Aircraft Design Certification GmbH Reichensteinstr.48 69151 Neckargemünd		Bristell B23 - Aileron AP system improvement	Doc-Nr: ADxC-73-SB-018 Issue: A Date: 14.10.2022 ChangeNr.: ADxC-DC-73-062
Service Bulletin

<p>Bristell B23 - Aileron AP system improvement</p> <p>Improvement of the bracket connection (also called “sleeve”) connecting the aileron AP push rod with the aileron control system.</p>
--

Modification of the aileron servo bracket

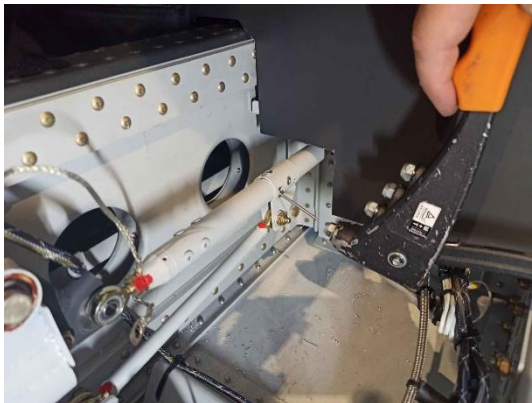
Drill the 4 holes (Drill bit diameter 3.2 mm) into bracket and aileron push rod. If the two original rivets are loosen, replace them with new ones. Thus, bracket and aileron push rod must be in in assembled position to each other before drilling the new holes.

- 5) install 4 rivets OBE61-0408 (3.2 x 6.6 mm)

Modification of the attachment of the dual control reinforcement rod

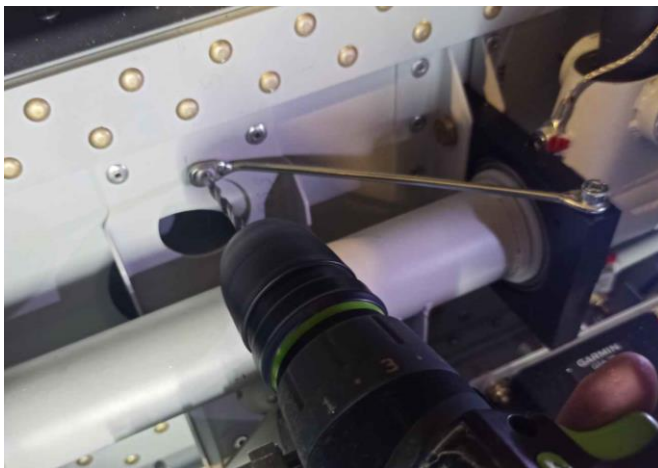
- 1) Undrill the front rivet of the dual control reinforcement rod (drill bit of dia. 4.1 mm) of pilot and co-pilot side.

- 2) Install both stainless steel rivets OBE61-0516 (4.1 x 12 mm).
